JSA/JEFFERSON LAB
CONSTRUCTION CHANGE REQUEST (CCR)

2 Project Title: Technology and Engineering Development Facility Project

3 CCR No: 16

4 CCR Title: Bent Plate at Knock Out Panels (4xTLA)

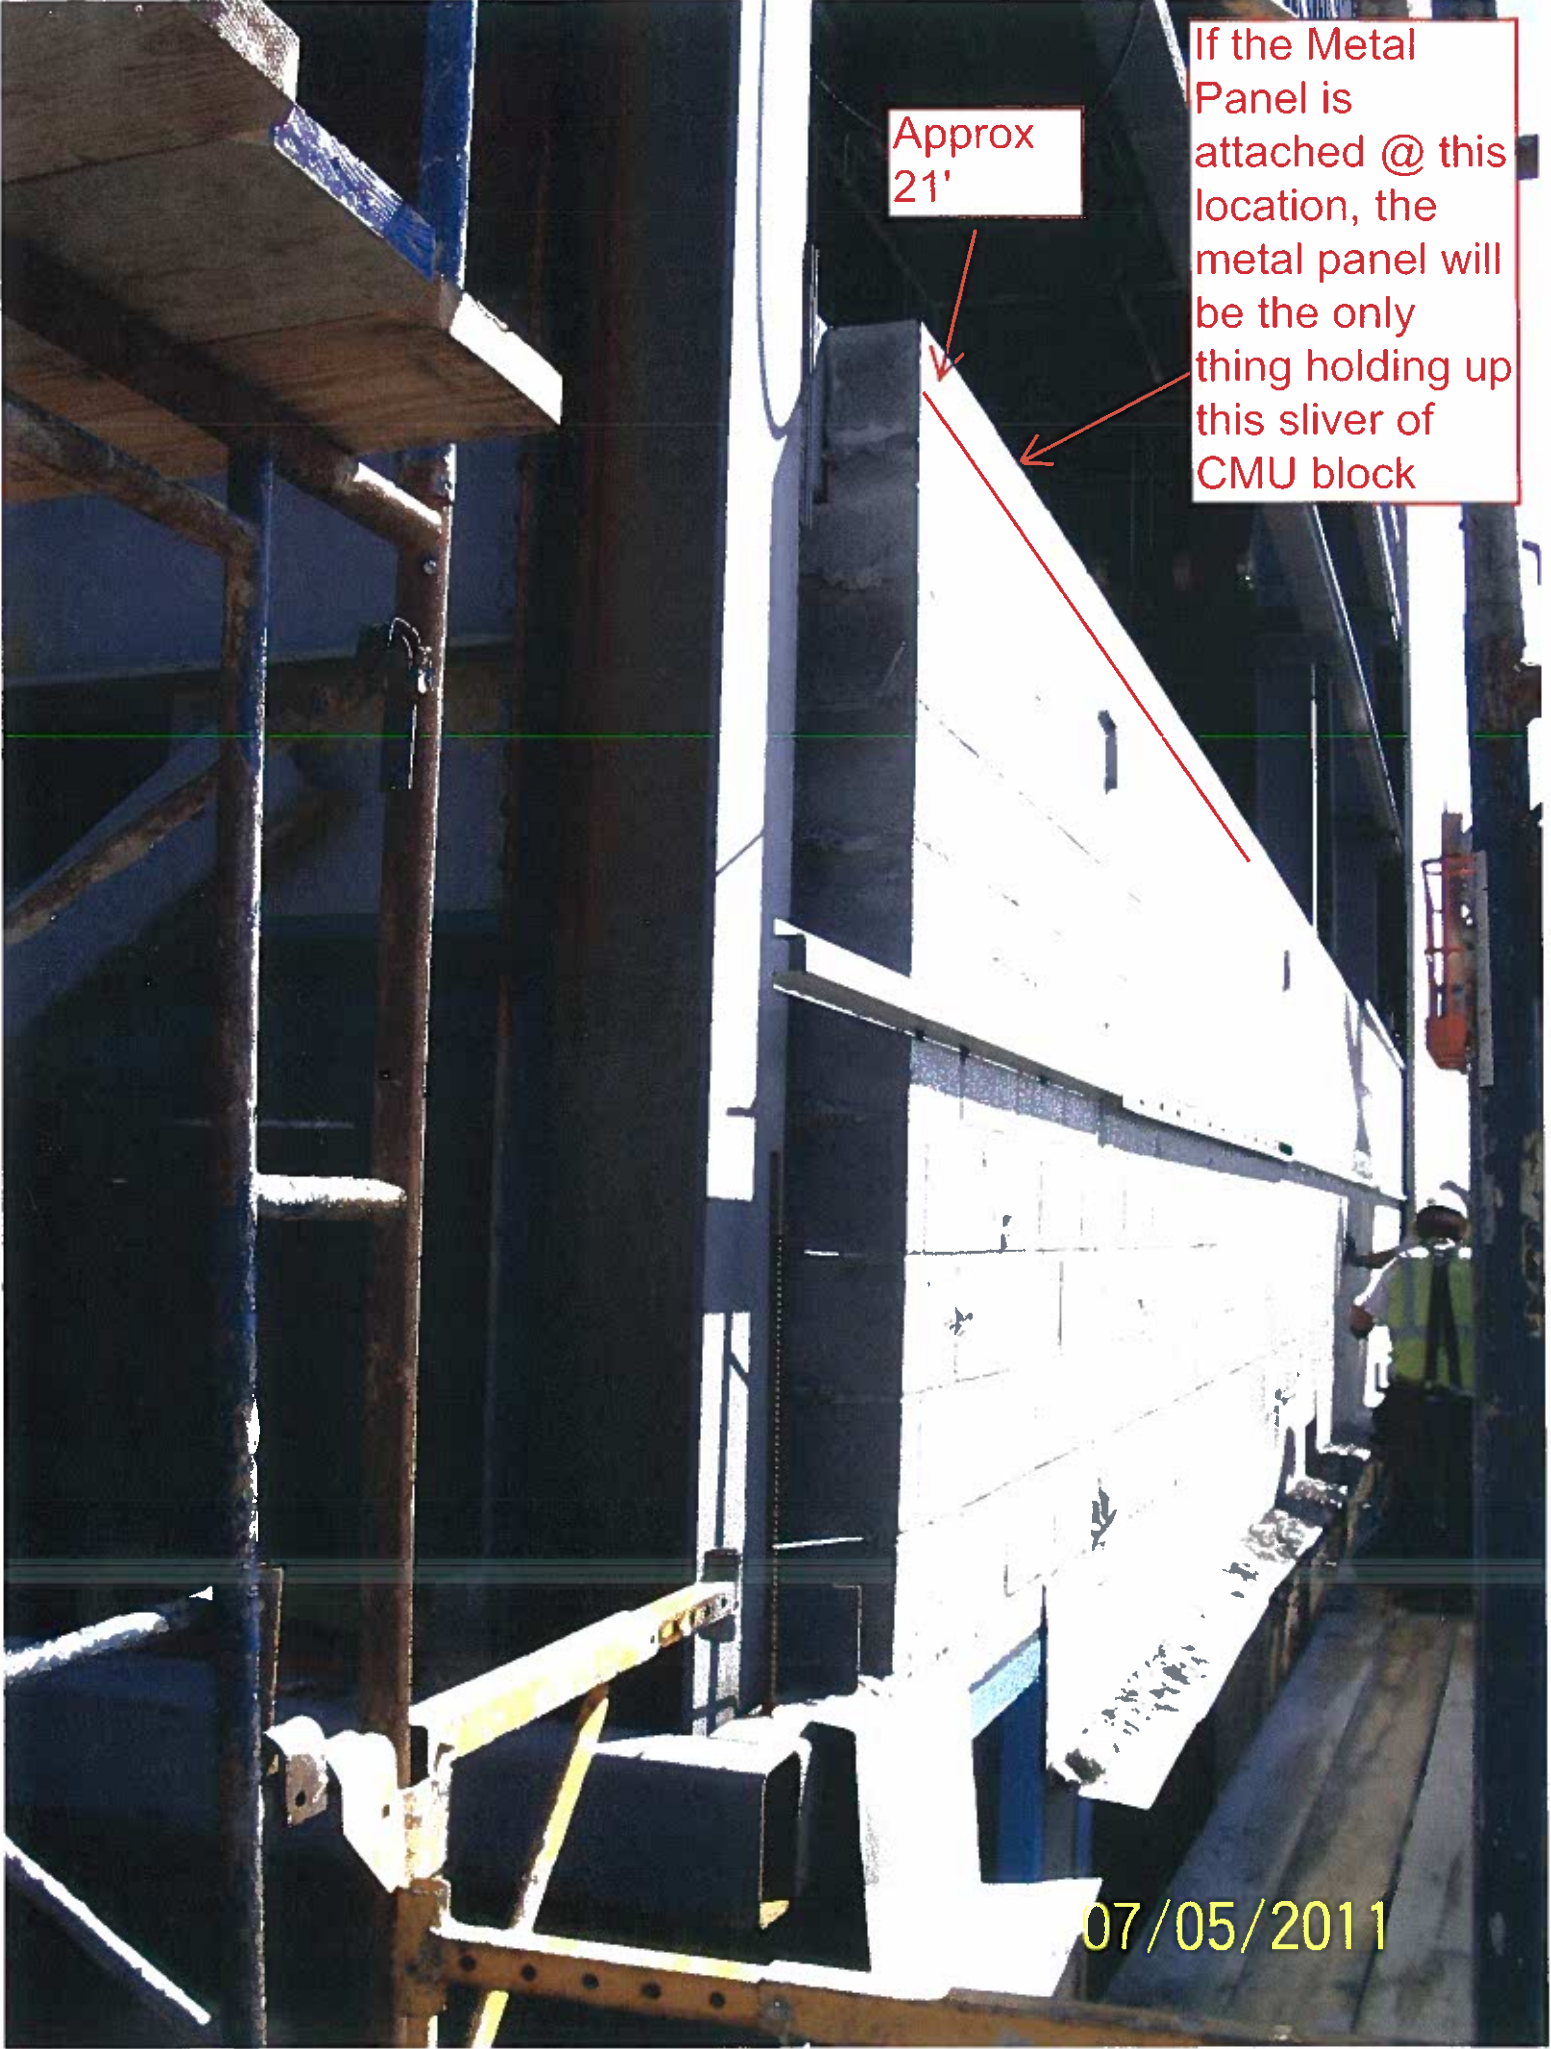
Request and/or Proposed Solution: The South knockout wall for the 450 ton press is to be at 21', the metal panel shop drawings show the panels to have a joint and fastened to CMU backup (1/D5). Please see attached picture for the approx. location of this joint for the knockout panel. When the CMU back up is removed to create the knockout opening, there will only be a sliver of CMU block that the metal panel subgirt can attached to, this CMU is also unsupported, and some sort of structural lintel/tube steel would be required. If the CMU back up is to be completed removed, the metal panel will need back up to attached the subgirt.

There is a very similar situation on the West side of TLA, but the knockout walls are at 20'.
Please review and advise.

Approx
21'

If the Metal
Panel is
attached @ this
location, the
metal panel will
be the only
thing holding up
this sliver of
CMU block

Please provide continuous 3/8" steel plate and weld to T.O. steel beam / tube above knock out panels. Knock out panel head joint to be 3" above T.O. steel at Equip. Platform level. See section detail on attached CPA-0029.

4 SECTION DETAIL AT HEAD OF EXTERIOR KNOCK OUT PANELS
3" = 1'-0"

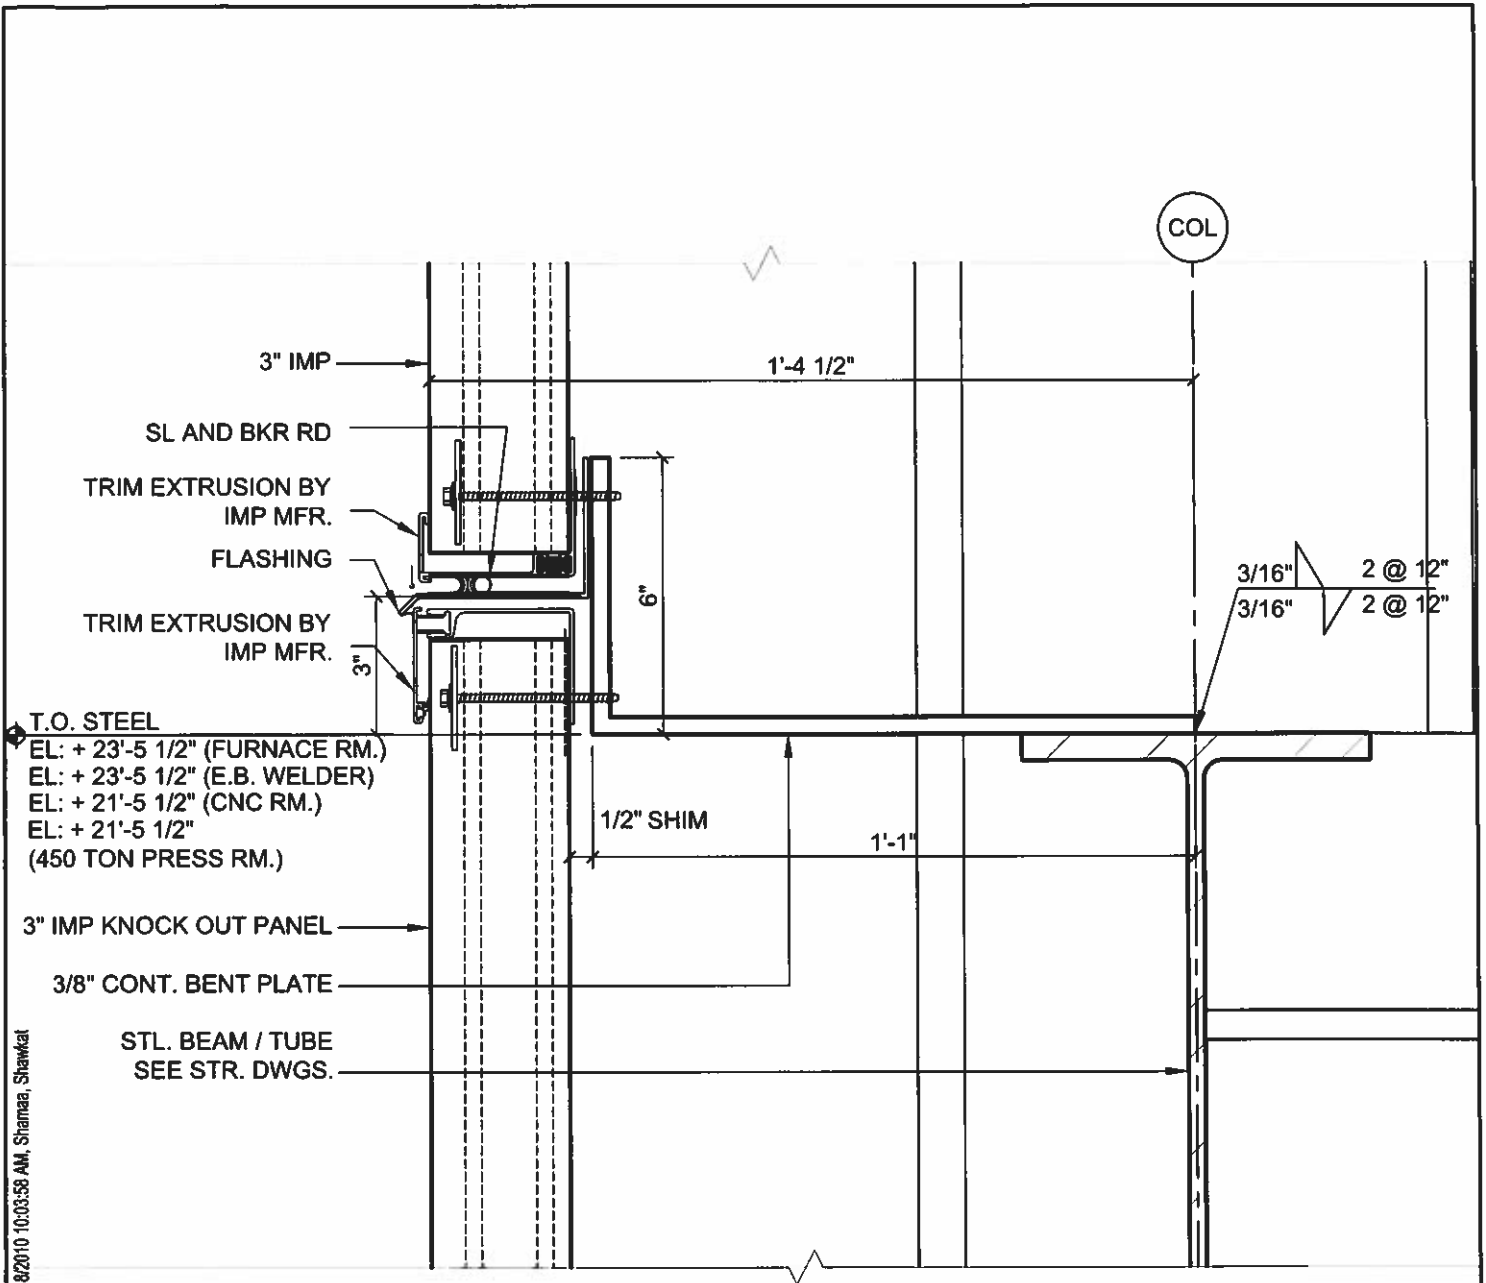
Add continuous 3/8" steel plate and weld to T.O. to steel beam/tube at the knock out panels at the Test Lab addition. (4 locations) See response to RFI 450
